MINI THERMOSTAT REDESIGN TO OVERCOME OVERHEATING ISSUES

Issue Date: 23/09/19 Issue Number: COTB0027B

APPLICATION: MINI R55, R56, R57, R58, R59, R60, R61

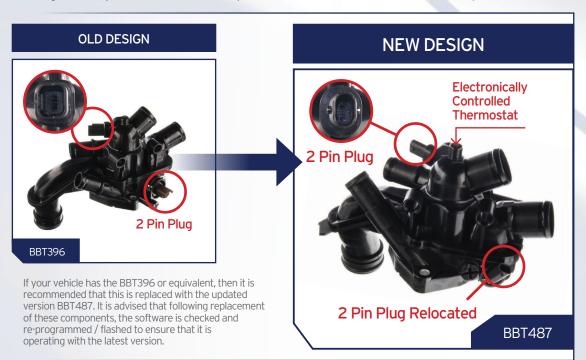
Due to an increase in overheating issues & symptoms such as an erratic temperature gauge, erratic running, radiator fan run-on, or poor heater function in the above vehicles, the O.E.M. have modified the design of the Thermostat housing. Following the O.E. specification, we have replaced the old design BBT396 with the new latest design BBT487. The latest design benefits from an electronically controlled thermostat, a reinforced structure, and a new configuration of sensors.

We have highlighted the key differences below so that you are clear that the latest part, although visually different to what may be on the vehicle, is in fact the correct product.

The modified version has had the lower 2 Pin connector relocated, therefore, a new cable may also be required to carry out the modification.

New Cable: BTS3092 - Thermostat Wiring Harness
